SITE PLAN

PART OF THE SOUTHWEST QUARTER, SECTION 29, TOWNSHIP 13 SOUTH,
RANGE 64 WEST OF TH 6TH P.M.,
COUNTY OF EL PASO, STATE OF COLORADO

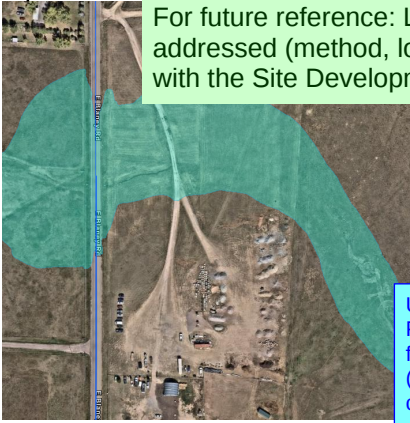
Label traffic ingress/egress.

You previously mentioned that this entrance is for business operations. Label and provide width measurements.

For future site plan changes, please keep in mind that all outside storage of vehicles and/or materials must be at least 50 ft from the property line and must be screened with fencing or landscaping.

At a minimum, the area must be depicted on this site plan. The specific method of screening can be addressed during the Site Development Plan if you choose to postpone providing that detail.

All outside storage, parking, and work areas are limited in combination to a 1-acre area. This needs to be clearly depicted.

Please depict areas of material, work vehicle, and employee vehicle storage. Refer to note on RIF Acknowledgement regarding a suggestion to consolidate outdoor footprint. If consolidating outdoor footprint from what is existing, please discuss in the letter of intent.

If this entrance is residential only, please label as such.

Unresolved Review 1 Comment:
Please depict the FEMA Floodplain from the Draft CWCB study on this site map. Please note that any future disturbance within the floodplain will require a floodplain development application (<https://www.pprbd.org/File/Resources/Downloads/Floodplain/FLPLApplication.pdf>) and a no-rise certification completed by a professional engineer.

This is a great site plan for current site conditions, but we need to address the proposed conditions. Details about the Home Occupation need to be called out and identified. Please add a focus area specifically for business use (similar to the "building detail" below).

Add "proposed" to everything that is not permitted but will be established and permitted through this process.

Please identify if these are residential accessory structures **OR** if they are accessory structures to be used as part of the Home Occupation.

Please identify what structures will be used for the Special Use

Existing access width on the south of the property does not appear to be drawn to scale (it's shown as smaller than actual).

Please revise to be 60' Public Local ROW.
